D868UV firmware update V1.26 and V2.26

V1.26 and V2.26 Improvements (dated 2018-3-12)

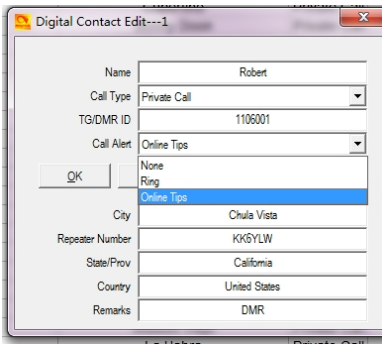
3. Add a Call Alert option in Digital Contact, when you set it to Online Tips, it will perform as below.

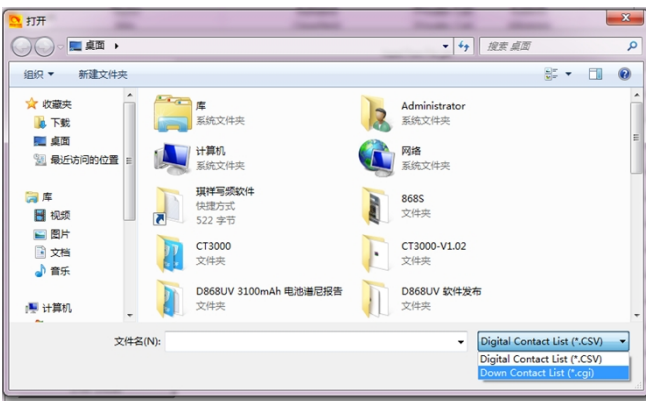
1. Since we have increased a Squelch off option for Analog mode afterwards FW2.23, when you open an old codeplug, please reset the analog squelch firstly.
2. Some reports the exported Talk Groups are missing some information, please remember to check on the boxes when you need more information, in CPS- Tool – Extended function.
